To: [Department of Planning, Industry and Environment](#)
Produced: Michele Zornitta (Associate Water Resources Engineer -WSP)
Reviewed: John Pickering (Associate Engineer - WSP)
Subject: **Waterloo Metro Quarter OSD**
SSD-10437 Southern Precinct – Response to submission comments
Date: 15 February 2021

Introduction

Waterloo - OSD
 Proposed Scenario - 1% AEP
 Water Level

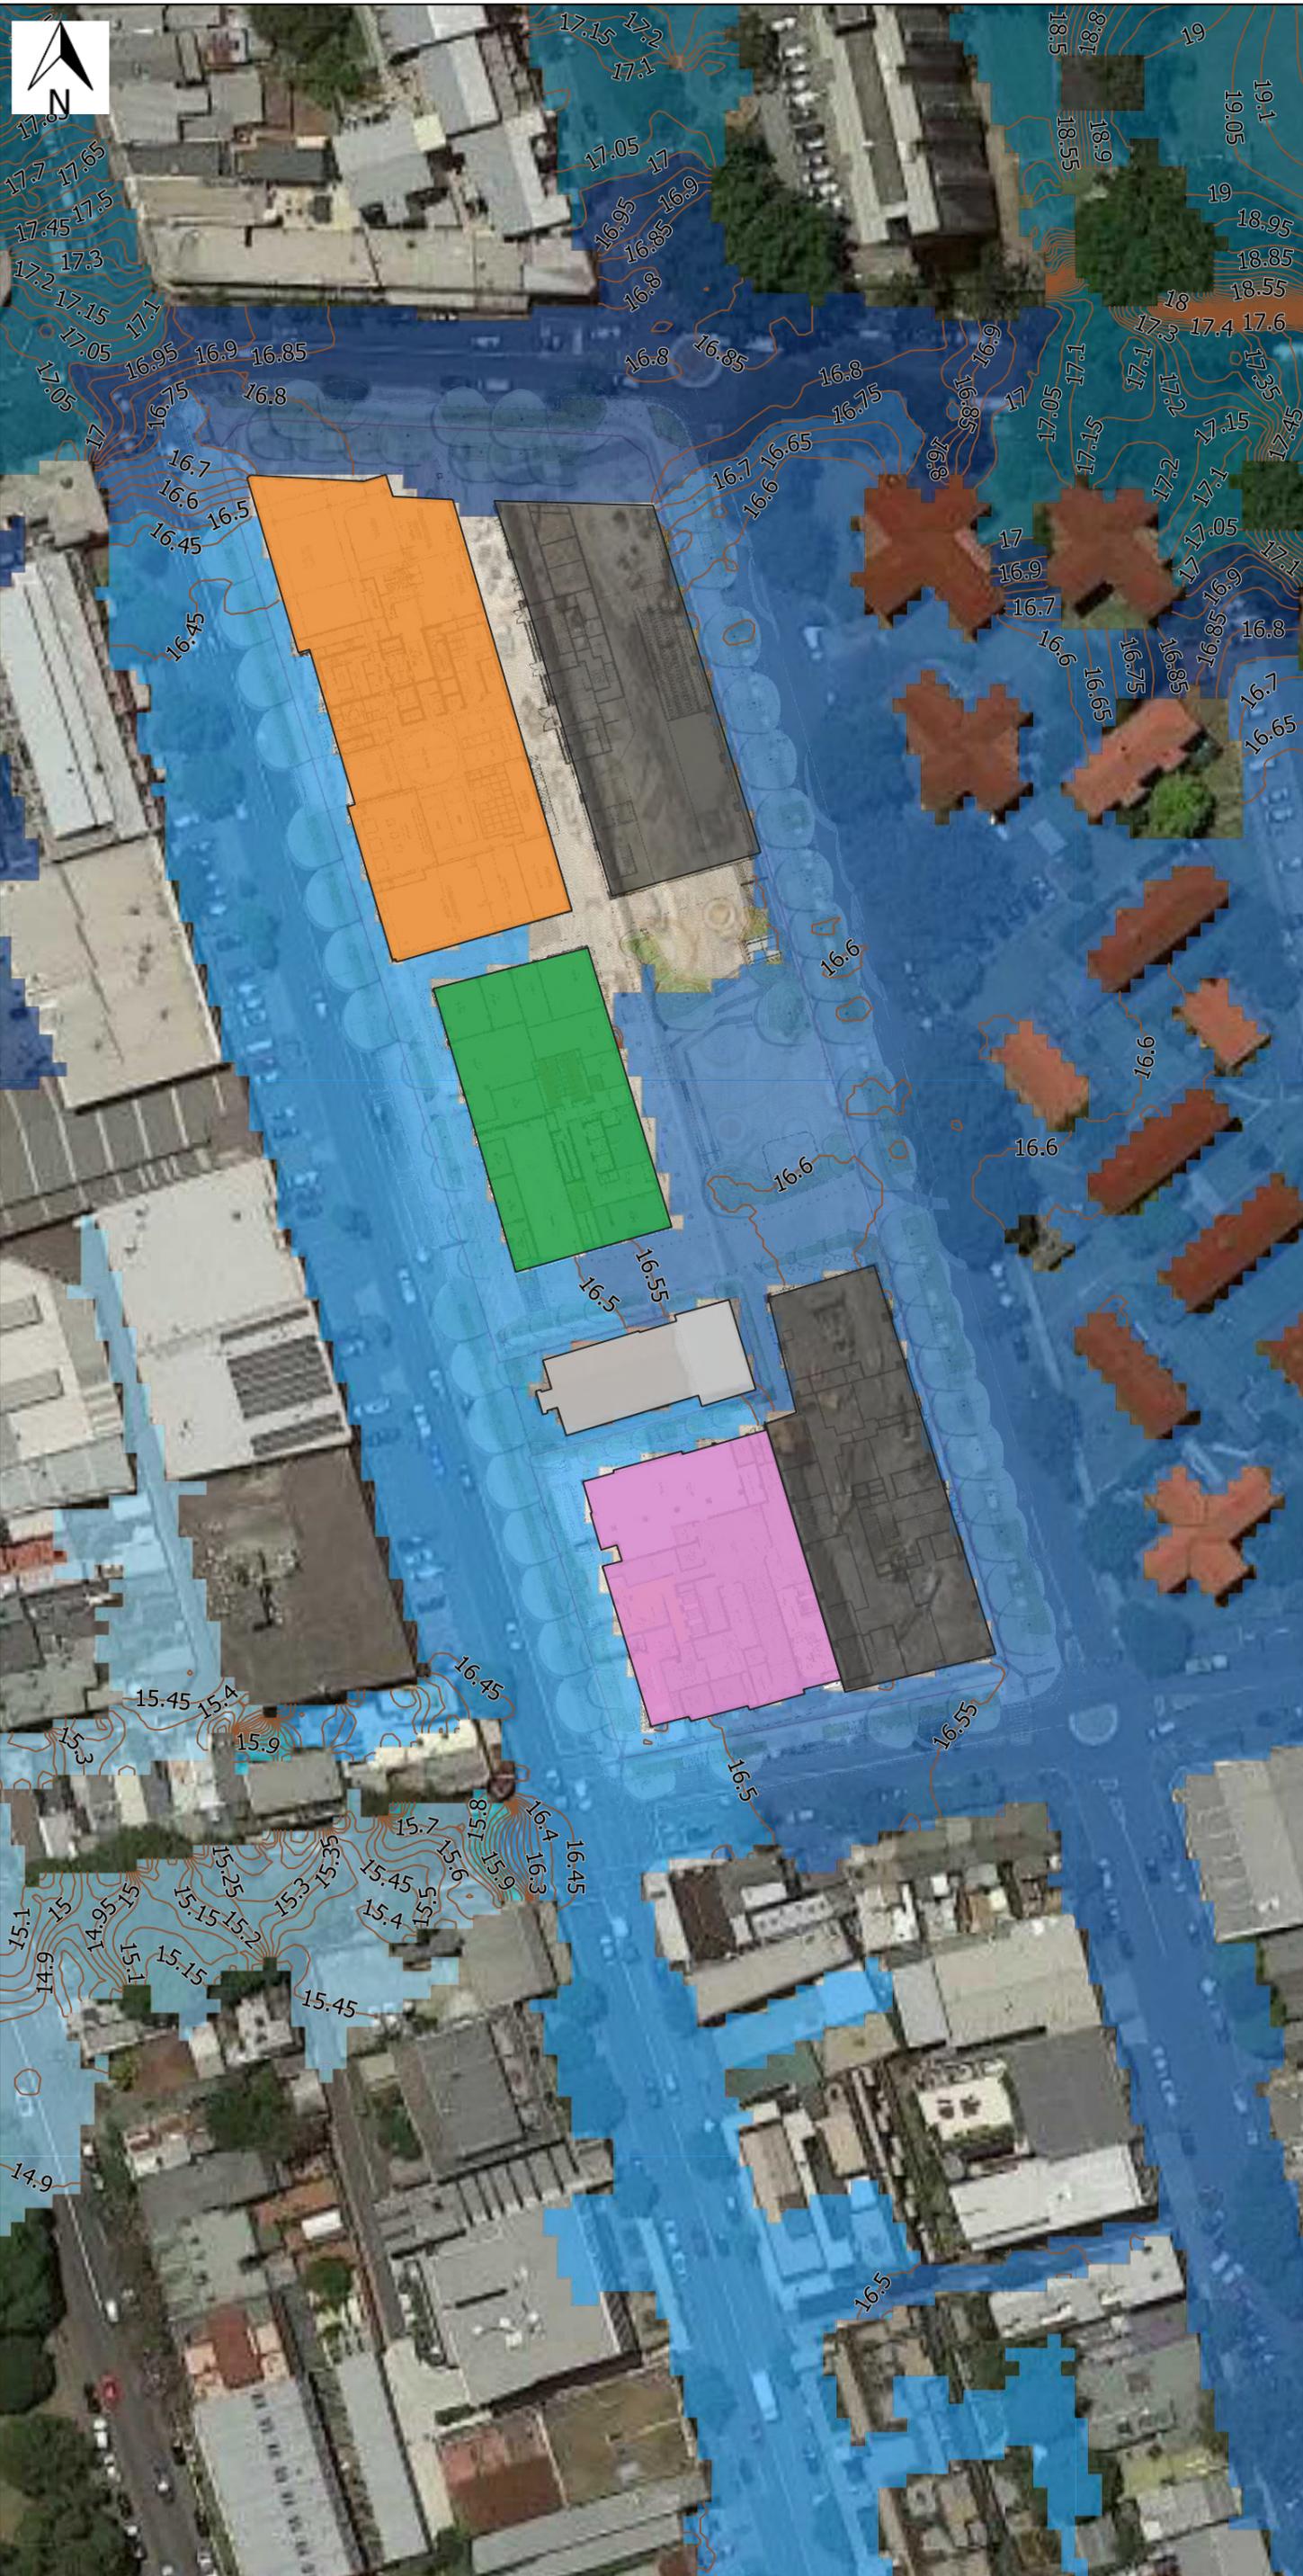
Comment	Response
Floodplain risk management	
<p>1 The reports have not included flood level mapping for any scenarios, except the 1% AEP flood event plus climate change. This is a significant omission. This mapping, including water level contours at appropriate intervals, must be provided as a minimum for the 5% and 1% AEP flood events and the PMF event. It is not possible to verify any of the flood level information quoted in the report without this mapping. A proper review of the submission cannot be completed until this has been provided. The frequency of typographical and grammatical errors does not give the reader any confidence that the appropriate degree of checking and verification has been completed in general.</p>	<p>Maximum flood levels for the 1%AEP, 1% AEP + Climate Change (CC) and PMF flood events are included in <i>Table 4: Design flood planning levels – Building Floor Levels of the Stormwater Management Strategy and Flood Impact Assessment – SSD-10437 Southern Precinct report</i>; flood levels included in Table 4 represent the maximum water levels for the 1%AEP, 1% AEP+CC and PMF flood events in correspondence to relevant building areas.</p> <p>Flood levels for the 5% AEP flood event was not originally included in the flood impact assessment report as not relevant in the determination of flood planning levels; flood planning levels have been informed by the 1% AEP, 1% AEP+CC and PMF maximum flood levels.</p> <p>Water level contour maps (with a 50mm contour interval) for the 5%AEP, 1% AEP and PMF flood events have been prepared and attached to this response as requested by the EES reviewer.</p> <p>The report and technical work developed for Waterloo Metro Quarter OSD has been reviewed and approved by the appropriate WSP flood engineers; the Flood Impact Assessment report has also been reviewed and approved by Waterloo OSD representatives.</p>
